TECHNICAL BULLETIN GE-36

DATE: January 2, 2007
 MODEL YEAR: 2005 - 2007
 ENGINE MODEL: J08
 CHASSIS MODEL: UD1800HD ~ UD3300
 BULLETIN NUMBER: GE-36
 FILE IN THE GENERAL SECTION OF THE TECHNICAL BULLETIN BINDER

2005 - 2007 J08 FLYWHEEL RESURFACING SPECIFICATIONS & DETAILS FOR MANUAL TRANSMISSIONS

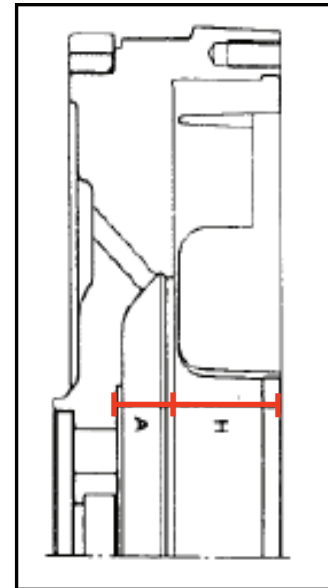
The Flywheel thickness specifications and resurfacing details shown on pages EN02-30, CL1-1-2 & CL1-3-9 in the 2005 & 2007 Service Manual CD are incorrect.

- 1) The correct flywheel thickness specifications are shown below.
- 2) The flywheel is serviceable until thickness (A) reaches the service limit. When grinding, also grind the flange so that the height (H) is within the maintenance standard. If flywheel has to be ground more than 1.0 mm (0.039 in), replace the flywheel.

Unit: MM (in)		
Inspection item	Standard	Limit
Flywheel		
(A) Thickness	(A): 21.0 (0.827)	20.0 (0.787)
(H) Height	(H): 43.0 (1.693)	44.0 (1.732)
